TE Connectivity

Product Change Notification: PCN-23-171053

General Product Description:
35 position AMPSEAL Wire Seal

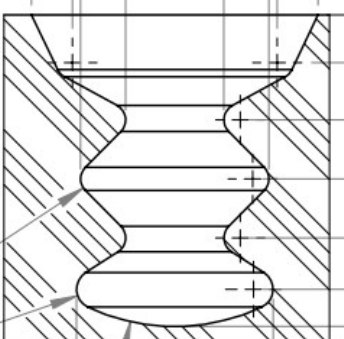
Please be aware of an upcoming feature and material change to the following part numbers 776164-1 776164-2 776164-4 776164-5 776164-6 The material change is to one of the components that makes up to the final material The feature change is to the ribs in the circuit holes and the sealing ribs on perimeter of the seal

Current circuit sealing ribs geometry is an older design 	New circuit sealing ribs geometry is a newer and updated design 
--	--
